Delegated Report		A	Analysis sheet		Expiry Date:	24/03/2023	
(Members Briefing)		Ν	N/A / attached		Consultation Expiry Date:	02/04/2023	
Officer				Application Number(s)			
Miriam Baptist				2023/0396/P			
Application Address				Drawing Numbers			
28 Parliament Hill London Camden				Please refer to draft decision notice			
NW3 2TN							
PO 3/4	Area Tean	n Signature	C&UD	Authorised Offi	cer Signature		
Proposal(s)							
Amalgamation of two flats into one single family dwelling. Mansard roof extension with dormer windows, new part two storey rear extension and ground floor roof terrace with rear spiral stair. Alterations to rear elevation windows. New entrance steps to the front of property, a new side access gate and new side access steps.							
Recommendation(s): Grant condition			onal planning	permission			
Application Type:		Full Planning Permission

Address: 28 Parliament Hill London Camden NW3 2TN

Amalgamation of two flats into one single family dwelling. Mansard roof extension with dormer windows, new part two storey rear extension and ground floor roof terrace with rear spiral stair. Alterations to rear elevation windows. New entrance steps to the front of property, a new

Image 7 (above): Proposed rear elevation (source: Application proposed drawings)

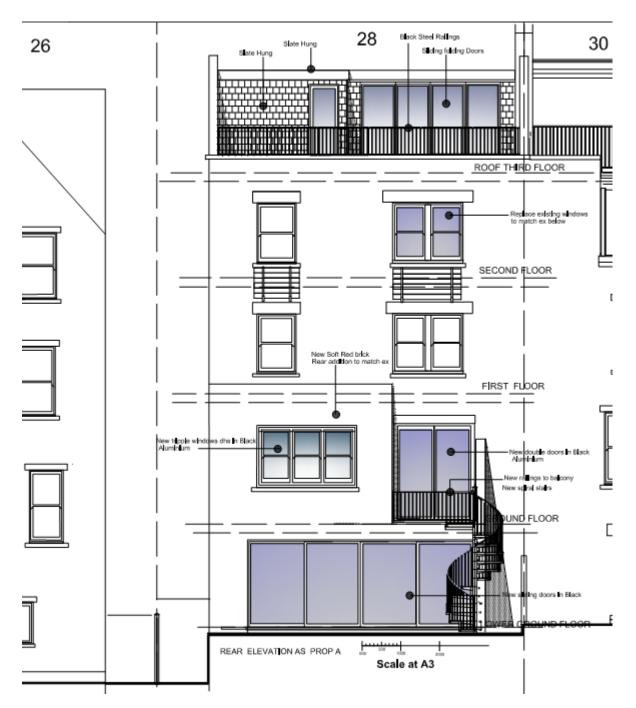
- 2.1.18 The rear extension put forward has taken into consideration the preapplication advice given, in that the upper ground floor level has been limited to being half-width. This serves to retain the visual hierarchy when viewed from the rear and confines the bulk of the mass to lower ground floor level. In this way the extension is subordinate to the host building. The detailed design is considered acceptable, the rear extension would be finished in brick and glazing. The projecting element at upper ground floor would have more traditional solid to glazing ratio, and larger expanses of glazing are set back or at lower ground level.

- 2.1.20 There are more general fenestration changes to the rear sought as part of the application. These changes have been informed by the preapplication advice previously given and are found acceptable. Where previously at pre-application stage widening of the window openings was sought at first and second floor, now the rear elevation is considered to maintain its vertical emphasis on the upper floors. To the lower levels wider areas of full height glazing are now made up of fewer individual panes of glass, causing the rear façade to appear less visually busy.

- 2.5.3 The 45-degree angle test has been shown on the proposed ground floor plan and passes the test. Figure A below shows the officer's assessment of the 45-degree angle test in elevation. The twostorey element extension blocks the 45-degree line of the lower ground floor window of No 26 to the south but because of the orientation of the properties, the impact on this window is not considered to be materially harmful in terms of loss of light. The extension is to the north of No 26, rather than to the south where there would be a greater impact on neighbouring daylight due to the direction of the sun. The affected window is also not the only glazing at this level of No 26 (Although the remainder of the façade is not shown on the drawing provided) and therefore the impact will be limited.

Image 8 (above): Proposed section showing mansard extension and rear extension (source: Application proposed drawings)

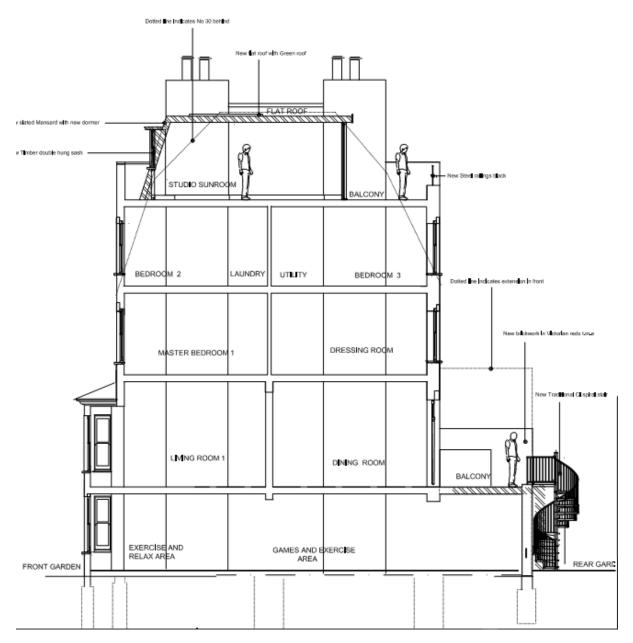
- 2.1.10 The initial proposal for a roof extension on the host property was considered to make its 'tower' massing in the street even more prominent, however the design has since been revised to further push back the mass of the mansard to reduce visibility from the street. The addition of a sloping mansard roof is considered to somewhat soften the existing blunt, flat-roofed form of the building, and being set back a minimum of 0.5m from the front of the property would ensure it would not appear overly dominant.

- 2.1.13 To the front, the mansard's dormer windows would be timber framed sash windows to match the existing windows below, and would align with the window openings below. The mansard roof would be hung slate and the flat section of the roof would have a green roof.

- 2.1.14 To the rear the roof extension does not take a mansard form but would be set back to accommodate an area of roof terrace like several properties along this stretch of properties. Similar to that of nearby properties, the rear of the the roof extension would feature full-height sliding glazed doors. The rear elevation of the roof extension would be hung with slate matching the front. Although the Council generally considers more traditional dormer windows to be more appropriate on a proposed mansard roof extension, given the existing character of the wider terrace includes a variety of built forms to neighbouring roof extensions, many of which include large glazed openings, the proposal would not be out of character and is considered acceptable in this instance.
